**BULLETIN NUMBER:**  
CB19-E-001

**FTR STEERING STOP JAM NUT REPLACEMENT – 19V-467**  
(Transport Canada 2019-306)

- 2018-2020MY Isuzu FTR Vehicles Wholesaled Before June 19, 2019

**Figure 1** – Right Front Stop Bolt Assembly

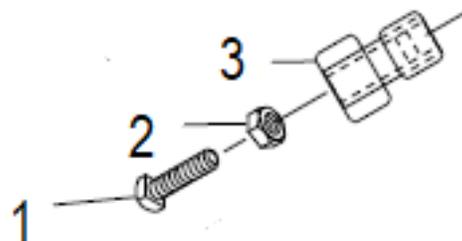
1. Apply the parking brake and block the rear wheels.
2. Start the engine and turn the steering wheel all the way to the left in order to access the right (passenger side) stop bolt. (See Figures 1 and 2.) Shut the engine off after turning the steering wheel.

Isuzu dealers will replace the existing left and right jam nuts with a Grade 8 jam nut, torque the nut to a new torque specification and apply Loctite to the nut and bolt. Where a bolt is damaged or missing the assembly will be replaced along with a Grade 8 jam nut. This service will be performed **free of charge**.

**Figure 3**

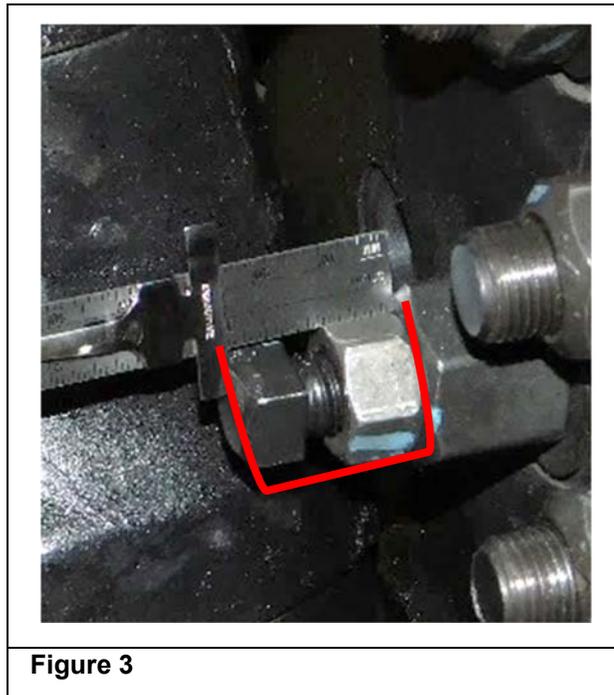
3. Use an engineer’s ruler to measure the distance that the stop bolt protrudes out from the adaptor base. (See Figure 3.) Record this measurement.

**Figure 5**

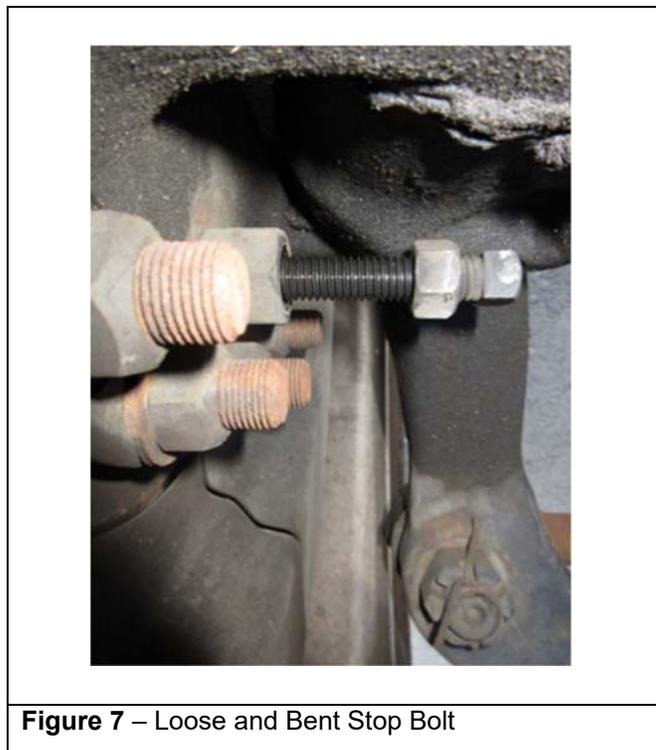
7. Clean the new Grade 8 jam nut with brake cleaner and a clean shop towel, install it on the stop bolt and thread the stop bolt back into the adaptor base.
8. Slightly hand tighten the jam nut to the adaptor. (See Figure 5.) Adjust the stop bolt until it is the same distance from the adaptor base measured and recorded in Step 3 (use a  $\frac{1}{2}$ " open end wrench as necessary). Using a  $\frac{3}{4}$ " deep well socket and a torque wrench, tighten the jam nut to the specified torque. (See Figure 6.)

**Tightening Torque:** 128 N•m (94 lb ft).

**Figure 12**

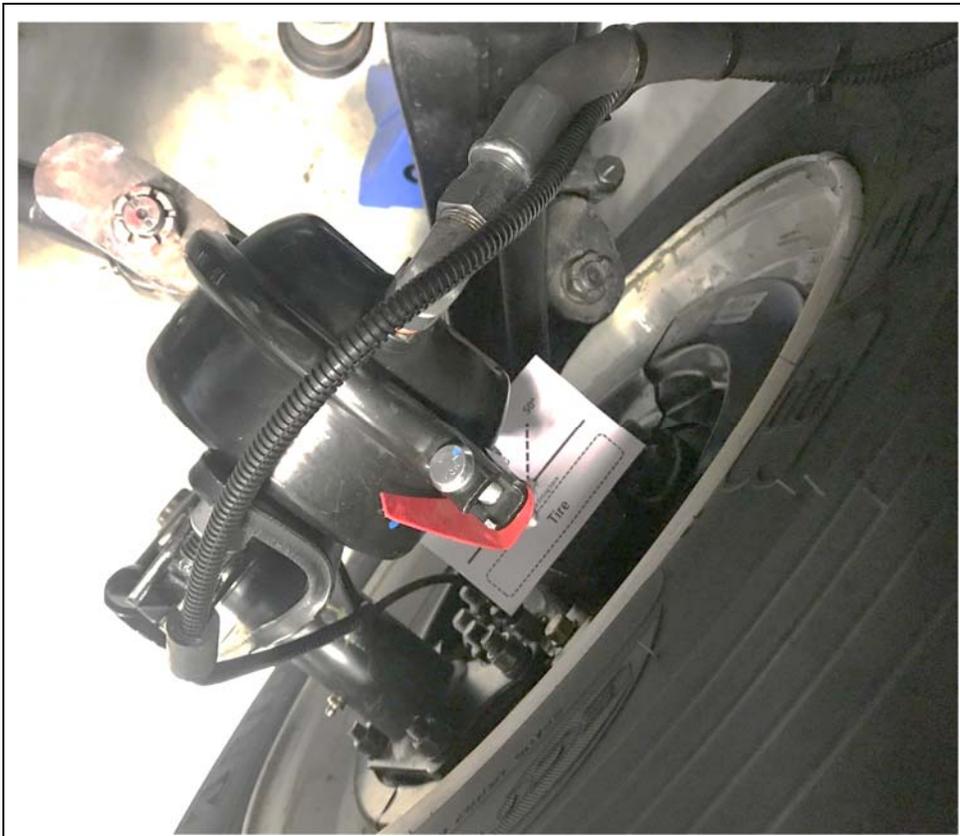
19. Install a new jam nut all the way onto the stop bolt.
20. Thread the stop bolt all the way into the adaptor that was installed in Step 18. Only tighten hand tight.
21. Start the engine and turn the steering wheel in the opposite direction of the wheel/stop bolt being replaced. Continue to turn the steering wheel until the template installed in Step 12 is the same as in Figure 12. The 50° dashed line on the template should align parallel with the casting mark through the center of the axle.

**Figure 13**

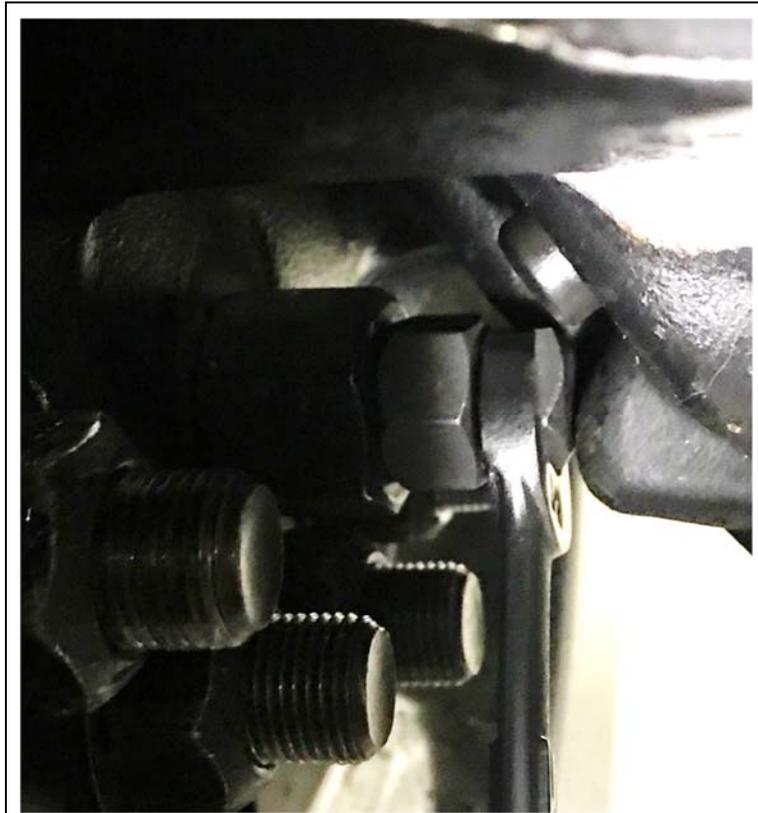
22. Using a 1/2" open-end wrench, adjust the stop bolt until the stop bolt contacts firmly against the axle bolt stop. (See Figure 13.) Ensure the template is still in the position shown in Figure 12.
